12
CITY PLANNING COMMISSION
1231 "I" STREET, SUITE 200, SACRAMENTO, CA 95814

APPLICATION: Variance to waive three of the required 30 parking spaces for a proposed 6,601± square foot medical/dental office to be located on 0.43± developed acres in the General Commercial (C-2) zone.

LOCATION: 3945 Marysville Boulevard
(Council District # 2)

APPLICATION NO. P92-067

SITE PLAN

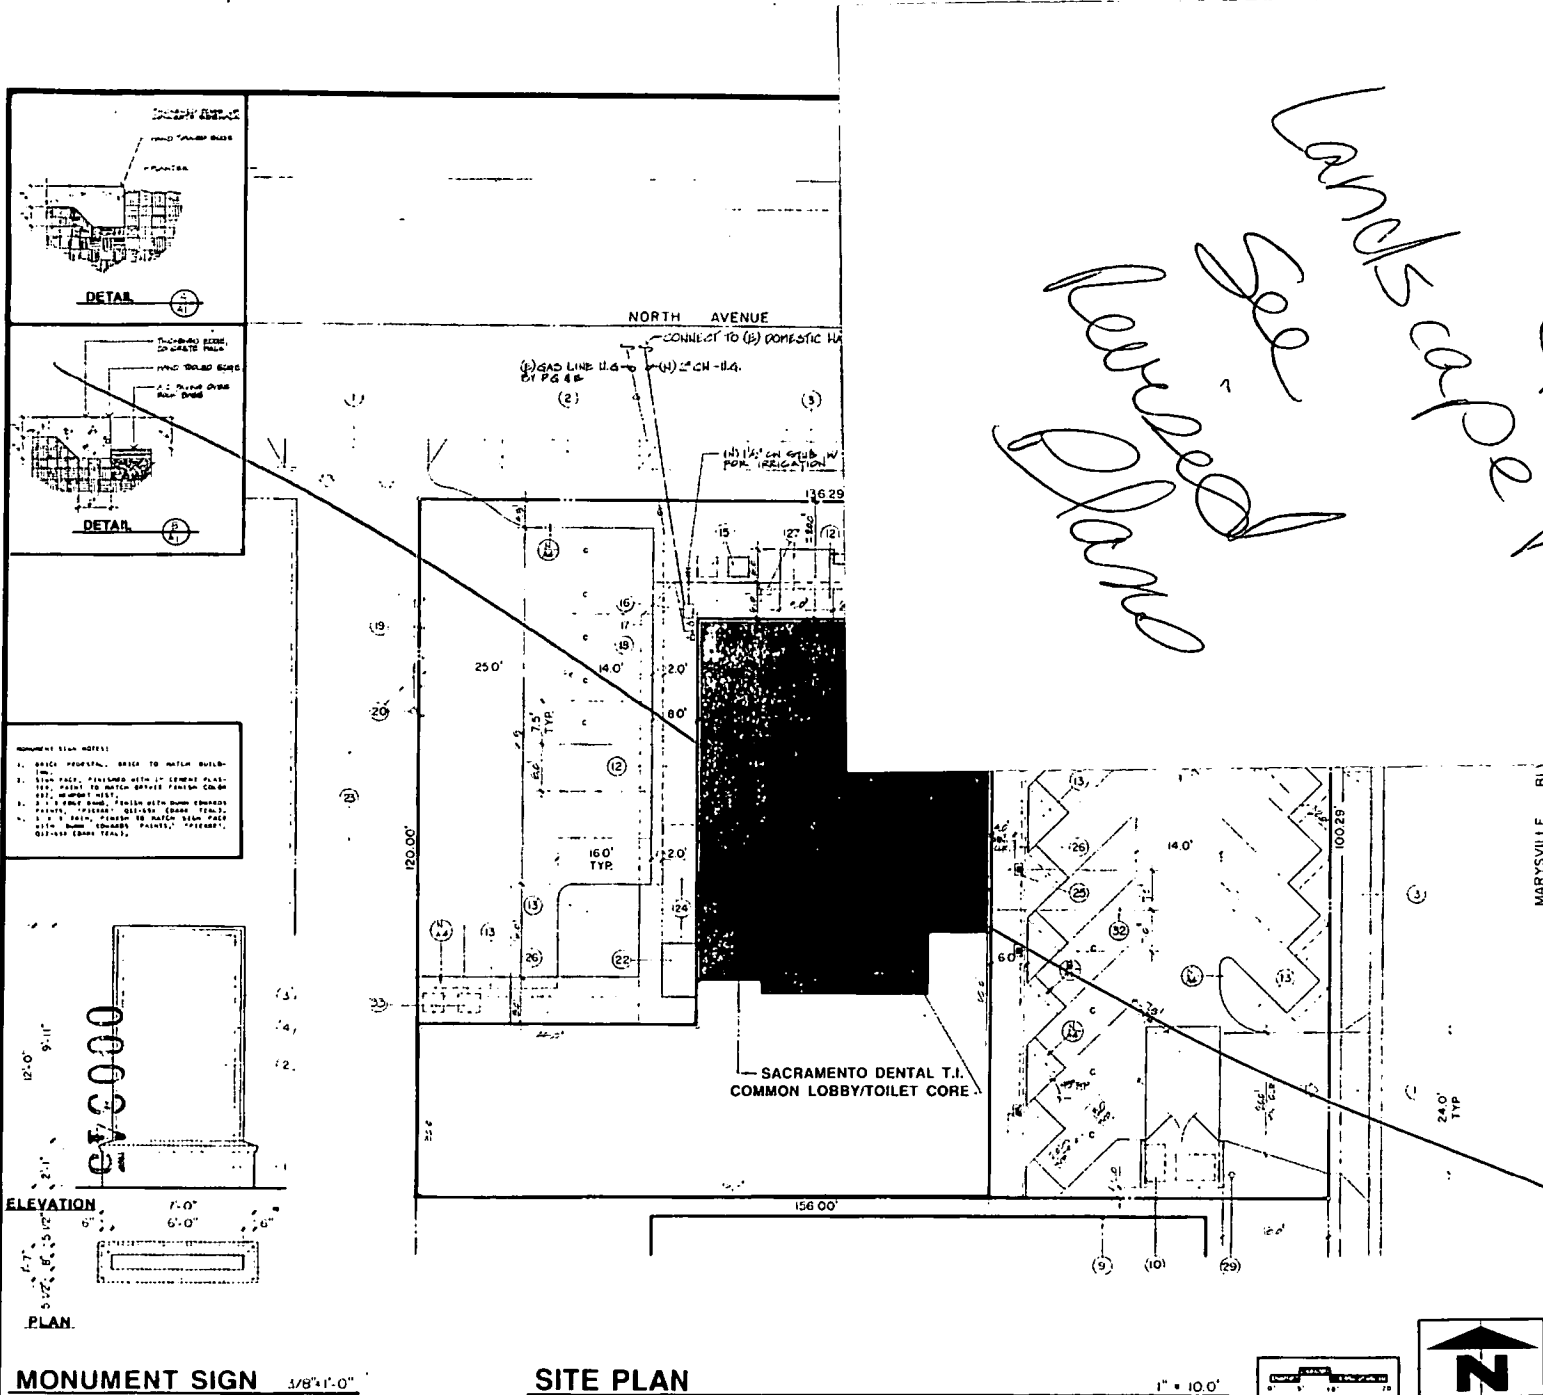
Planning staff has met with the applicant in regards to the existing paved area to the rear of the existing building which is adjacent to the alley along the western property line. The applicant's original proposal involved utilizing the alley for access to the proposed parking area; however, the applicant has been informed by the Development Services Division of Public Works that if the alley is utilized they will be required to pave the alley the entire length of their property. In order to reduce the financial impacts of the proposed project the applicant has redesigned the parking lot in order to utilize on-site parking, maneuvering and driveways. In addition they are also requesting to install a six foot high wrought iron fence along the western property line adjacent to the alley to insure that the alley is not utilized by visitors or employees of the medical/dental facility. In addition to the fencing along the alley the applicant is also proposing to install wrought iron fences

In order to utilize the adjacent alley for maneuvering the alley will be required to be paved according to City standards. The applicant has submitted a revised site plan (Exhibit E) which would not require the use of the alley. Planning staff has met with staff from Traffic Engineering and Development Services to review the revised parking plan and have no objections to the revised plan as shown on Exhibit E. In order to utilize the revised parking plan the large planter to be located along the alley will be eliminated. Planning staff recommends that the applicant submit a revised landscape plan for review and approval prior to issuance of building permits.

1. The alley adjacent to the parcel shall be constructed to City standards;
2. Replace driveways to be abandoned with curb, gutter and standard sidewalks.

1. The proposed monument sign shall be designed to meet the City's visibility requirements.
2. The applicant shall submit a revised parking plan to the Traffic Engineering Division for approval prior to issuance of building permits.

1. The parking lot shall be revised to include the striping as shown on Exhibits E attached;
2. The applicant shall submit a revised landscape plan to the Planning Director for review and approval prior to issuance of building permits;
3. The applicant shall submit detailed sign plans indicating the height and design of the sign copy to the Planning Director and Design Review staff for review and approval prior to issuance of sign permits;

MONUMENT SIGN 3/8"=1'-0"

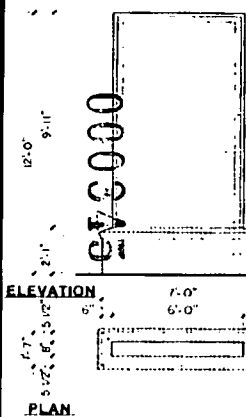
The subject site is a corner parcel zoned General Commercial (C-2) which allows for two detached signs. In reviewing the applicant's renovation plans Design Review staff recommended that the existing pole sign be removed and a monument sign be utilized for the detached sign. Due to the proximity of the eastern driveway along North Avenue a monument sign could not be utilized unless additional parking spaces were removed in order to meet the minimum required distance from driveways and property lines. As the existing pole sign was constructed and permitted approximately one year ago and the sign is approximately only 14 feet in height Planning staff has no objections to the existing pole sign being retained provided that the subject site be restricted to one detached sign. As the subject site is within the boundaries of the Del Paso Heights Redevelopment Area the applicant will be required to submit revised sign plans to Design Review staff for review and approval prior to issuance of sign permits.

4. The detached pole sign for the subject site shall not exceed the overall height of the existing pole sign (approximately 14 feet);
5. Only one detached sign shall be permitted on the subject site;
6. The applicant shall obtain approval from the Public Works Department on the location of the proposed fencing and gates that will enclose the subject site prior to installation of the fencing; and
7. The applicant shall submit a site plan to the Traffic Engineering Division prior to issuance of building permits.
8. In order to mitigate the three vehicle parking spaces which have been waived the applicant shall provide the following:
 - a. 2 - Class I bicycle lockers which can accommodate 4 bicycles; and
 - b. 1 - Class III bicycle rack which can accommodate a minimum of 3 bicycles.

LANDSCAPE PLAN

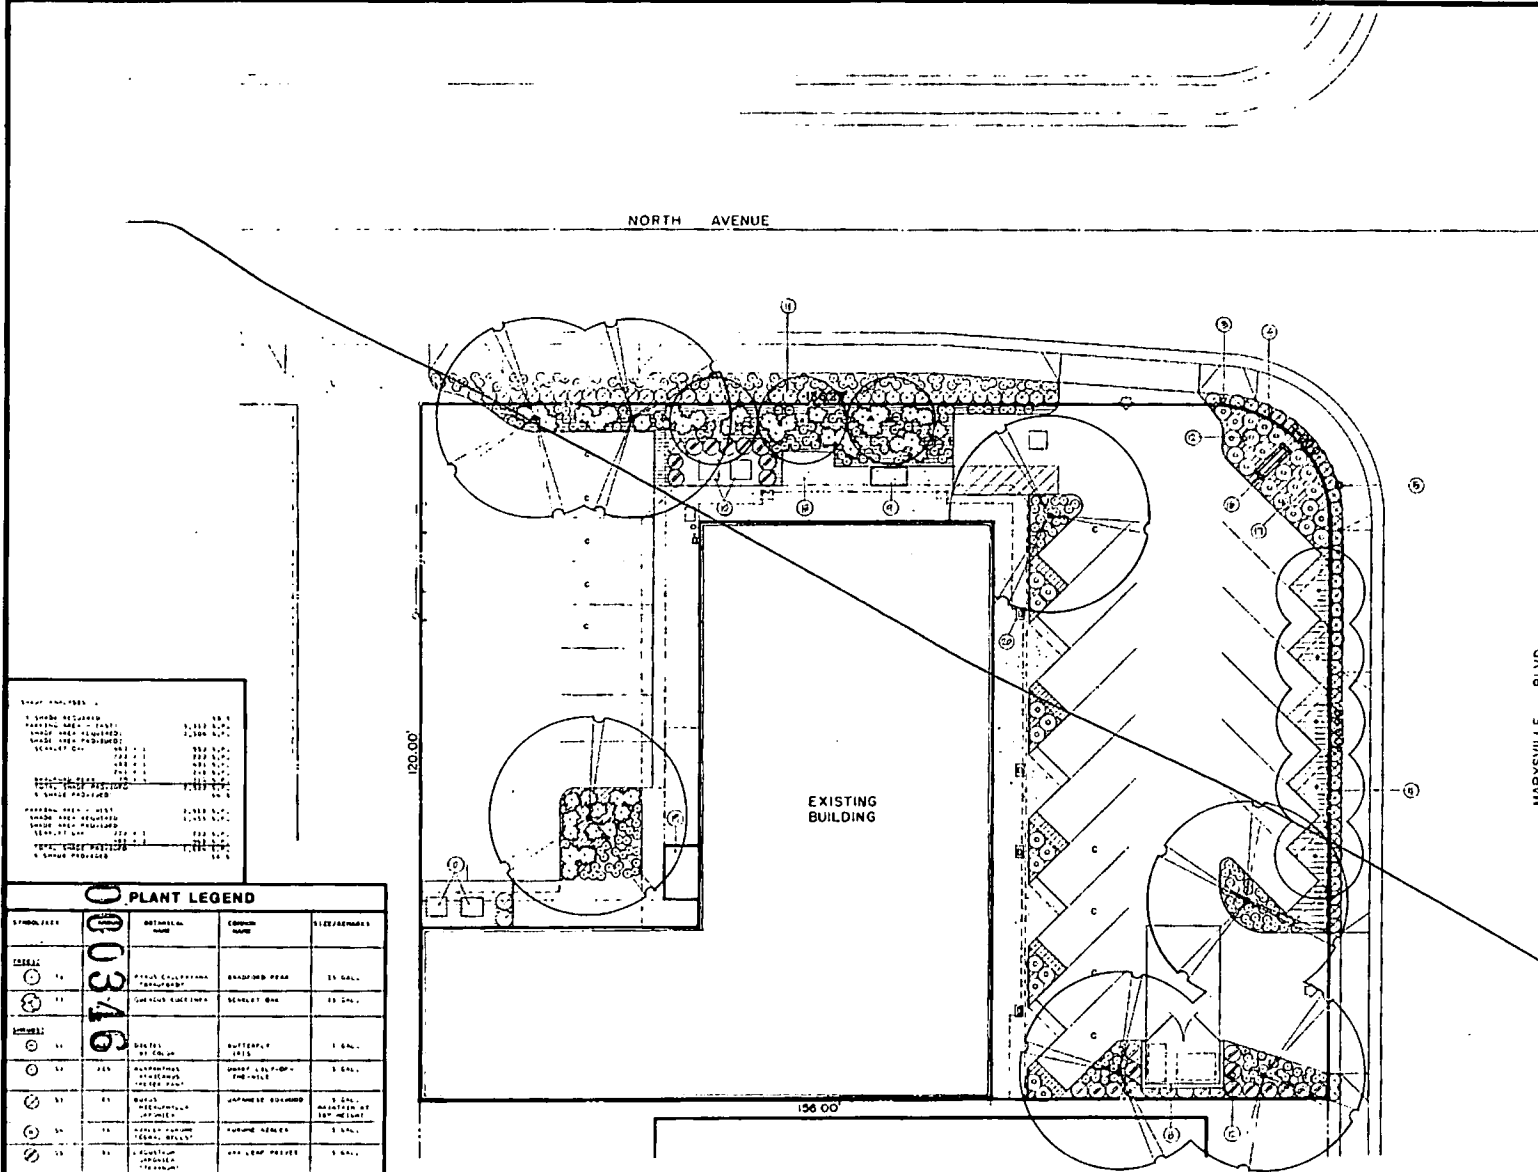
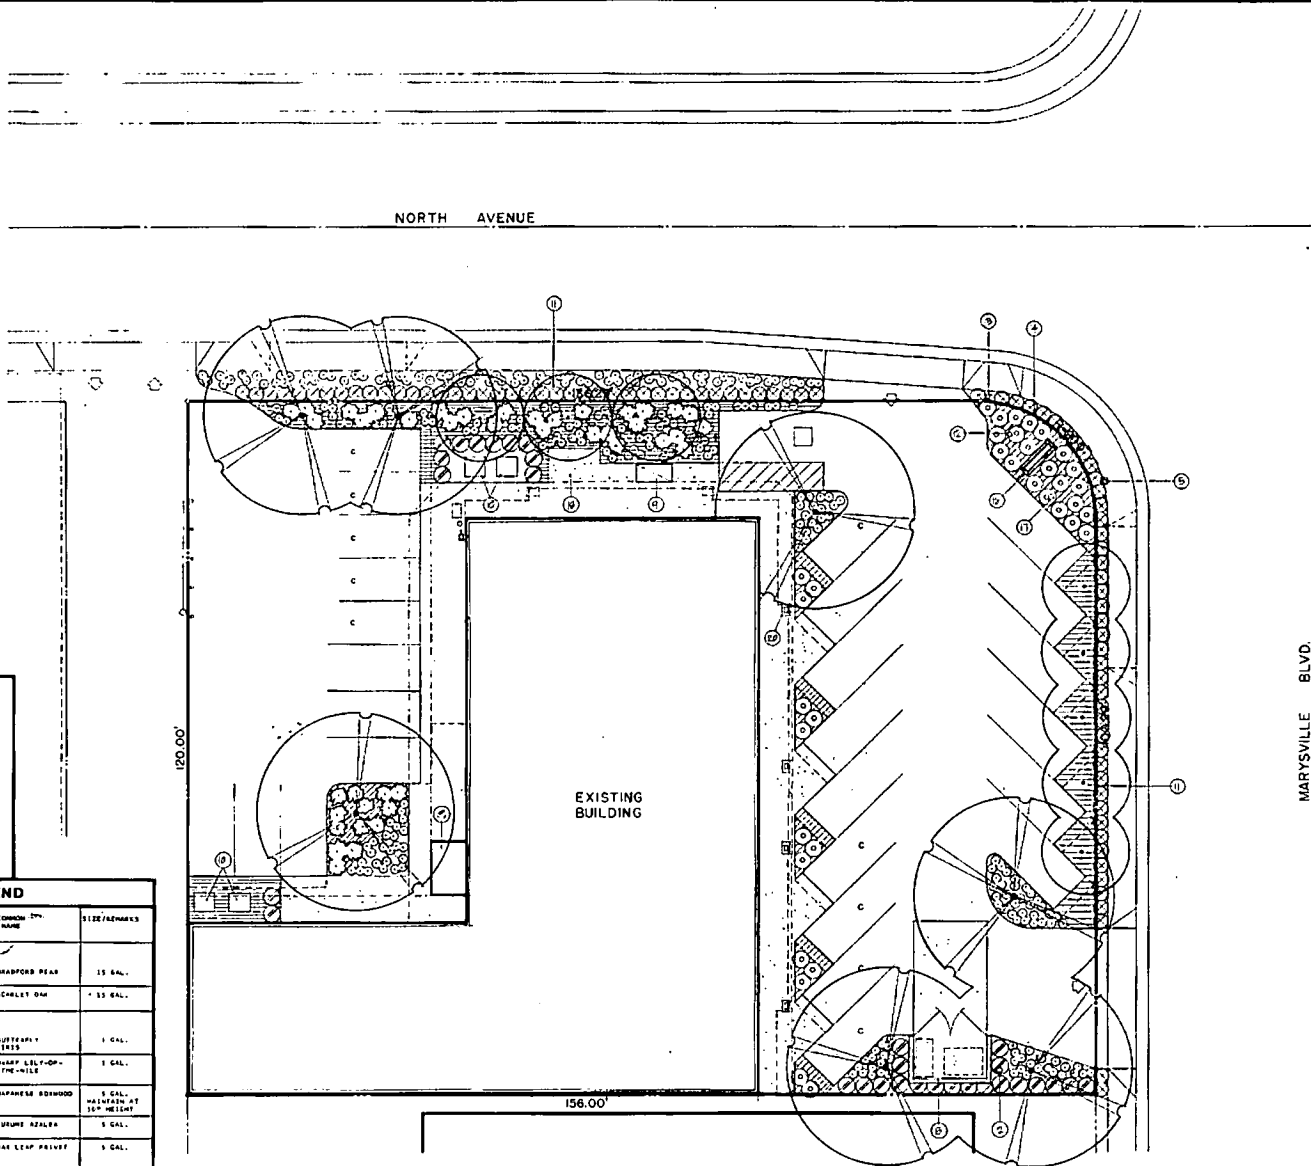
The existing site currently does not meet the Zoning Ordinance requirements for landscaping and shading. As part of the remodel to the existing building the project was required to go through the Design Review staff for approval of the exterior renovations and the parking lot layout. The landscape plan (See Exhibit B) which was submitted by the applicant and has been approved by Design Review staff indicates that approximately 50% of the paved surface will be shaded. In addition to providing parking lot tree shading the applicant will also be installing planters along North Avenue and Marysville Boulevard and within the parking lot.
